Well Name: MUY WAYNO 18-7 FED COM	Well Location: T25S / R30E / SEC 18 / NESW / 32.126774 / -103.924959	County or Parish/State: EDDY / NM
Well Number: 403H	Type of Well: OIL WELL	Allottee or Tribe Name:
Lease Number: NMNM120898	Unit or CA Name:	Unit or CA Number:
US Well Number:	Operator: XTO PERMIAN OPERATING LLC

Notice of Intent

Type of Action: APD Change

Procedure Description: XTO Permian Operating, LLC. respectfully requests approval to make the following changes to the approved APD. Changes include SHL, KOP, FTP,LTP,BHL, proposed total depth and pool FROM: TO: SHL: 1436' FSL & 1375' FWL OF SECTION 18-T25S-30E 1626' FSL & 1375' FWL OF SECTION 18-T25S-30E KOP: 2043' FSL & 1434 FWL OF SECTION 18-T25S-30E 1493' FSL & 2578' FWL OF SECTION 18-T25S-30E FTP: 2559' FNL & 1435' FWL OF SECTION 18-T25S-R30E 2554' FNL & 2525' FWL OF SECTION 18-T25E-30E LTP: 100' FNL & 1435' FWL OF SECTION 7-T25S-R30E 100' FNL & 2357' FWL OF SECTION 7-T25S-R30E BHL: 10' FNL & 1435' FWL OF SECTION 7-T25S-R30E 10' FNL & 2357' FWL OF SECTION 7-T25S-R30E The proposed total depth is changing FROM: 17603' MD; 9294' TVD TO: 18270' MD; 9282' TVD. Pool code is changing FROM: Pierce Crossing; Bone Spring, East (964

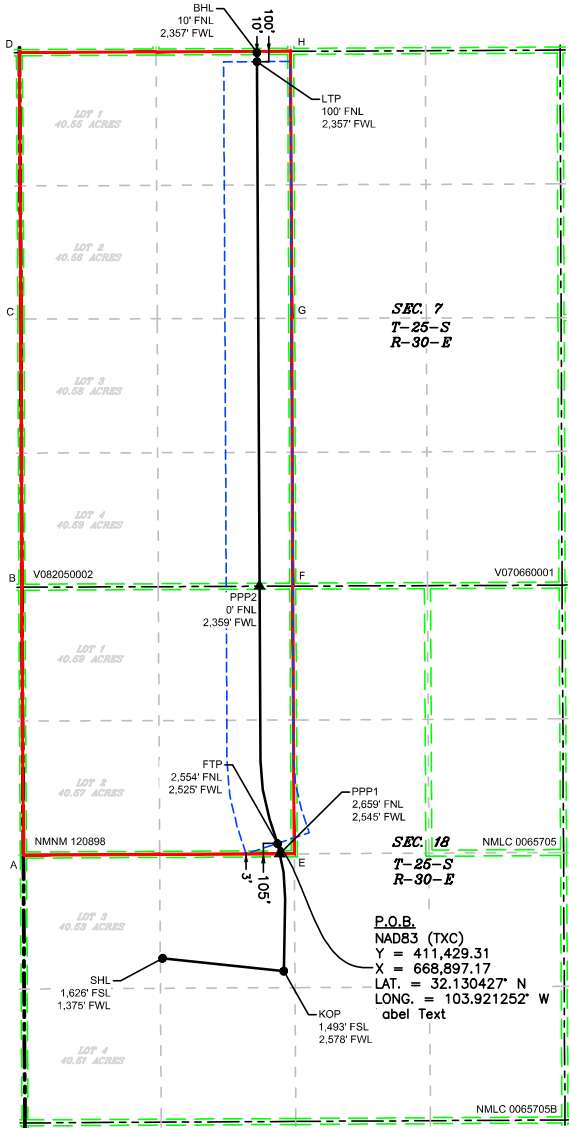
XTO Permian Operating, LLC, respectfully requests approval to make the following changes to the approved APD. Changes include SHL, KOP, FTP,LTP,BHL, proposed total depth and pool

FROM: TO:

SHL: 1436 FSL & 1375 FWL OF SECTION 18-T25S-30E 1626 FSL & 1375 FWL OF SECTION 18-T25S-30E
KOP: 2043 FSL & 1434 FWL OF SECTION 18-T25S-30E 1493 FSL & 2578 FWL OF SECTION 18-T25S-30E
FTP: 2559 FNL & 1435 FWL OF SECTION 18-T25S-R30E 2554 FNL & 2525 FWL OF SECTION 18-T25E-30E
LTP: 100 FNL & 1435 FWL OF SECTION 7-T25S-R30E 100 FNL & 2357 FWL OF SECTION 7-T25S-R30E
BHL: 10 FNL & 1435 FWL OF SECTION 7-T25S-R30E 10 FNL & 2357 FWL OF SECTION 7-T25S-R30E

The proposed total depth is changing FROM: 17603 MD; 9294 TVD TO: 18270 MD; 9282 TVD.

Pool code is changing FROM: Pierce Crossing; Bone Spring, East (96473) TO Corral Canyon; Bone Spring, South (13354)

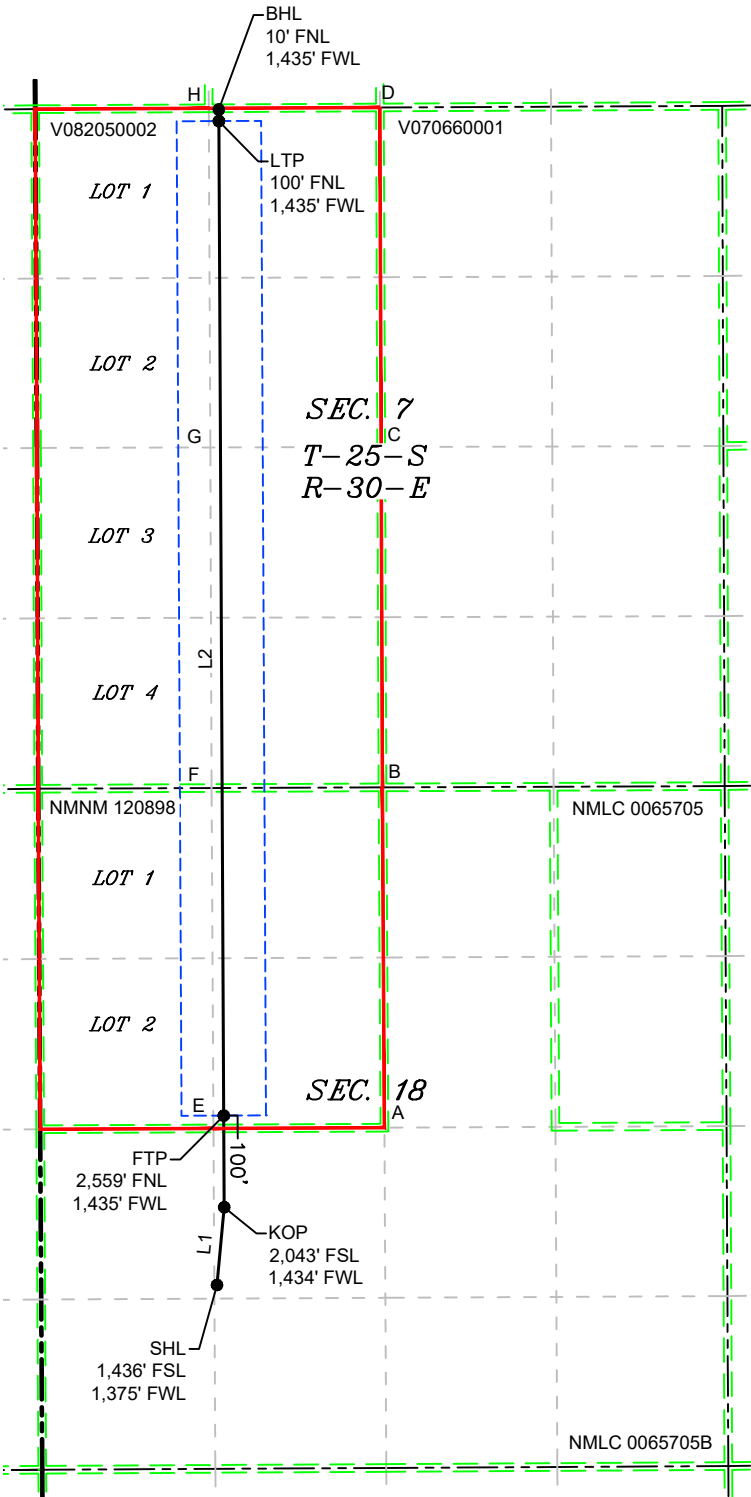
XTO Permian Operating, LLC. respectfully requests approval to change the name of this well from "MUY WAYNO 18 FEDERAL 403H" to "MUY WAYNO 18-7 FED COM 403H".
